May 10, 2016

RE: Request for License Amendment to add new models
Docket No. 030-38834, Letter Dated April 13, 2016

**A. REQUEST FOR ADDITIONAL INFORMATION REGARDING EXEMPT
DISTRIBUTION LICENSE AND SEALED SOURCE AND DEVICE REGISTRATION
(SSD) CERTIFICATE**

Sentry Chrono Tritium T100

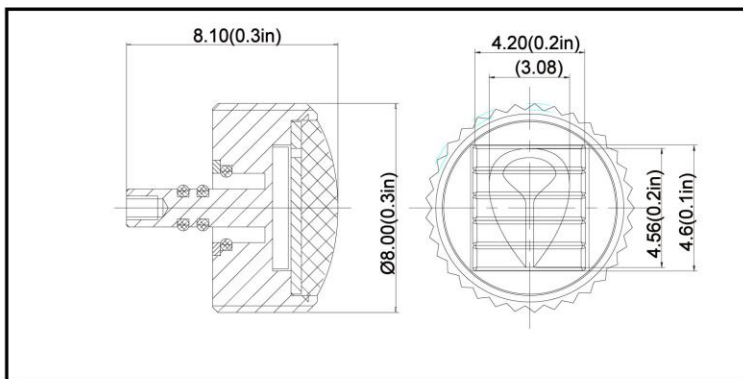
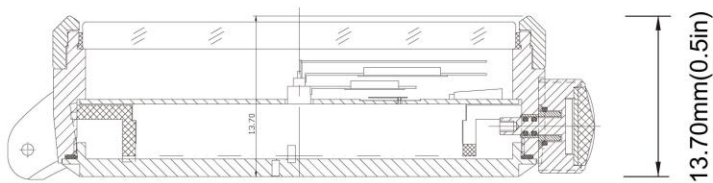
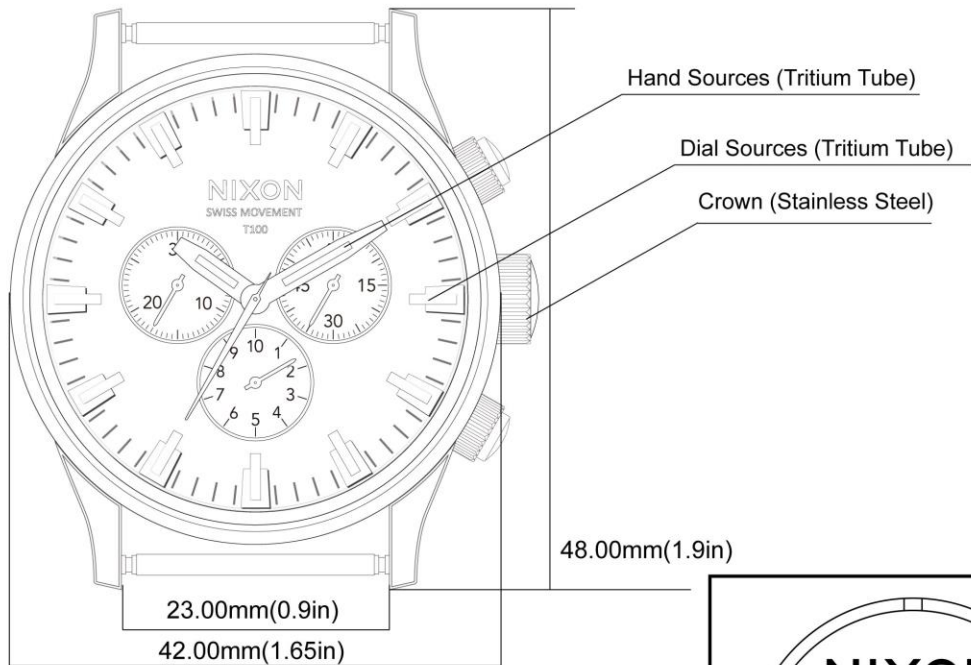
1. In your letter you provided drawings for the Sentry Chrono timepiece. The second drawing for the Sentry Chrono timepiece had dimensions that could not be read, specifically the dimension on the side view. Please resubmit a copy of the drawing, with readable dimensions. In addition, please ensure that all of the dimensions in the drawing include units of measure.

See Attachment B for clearer drawings with dimensions labeled in English and Metric units.
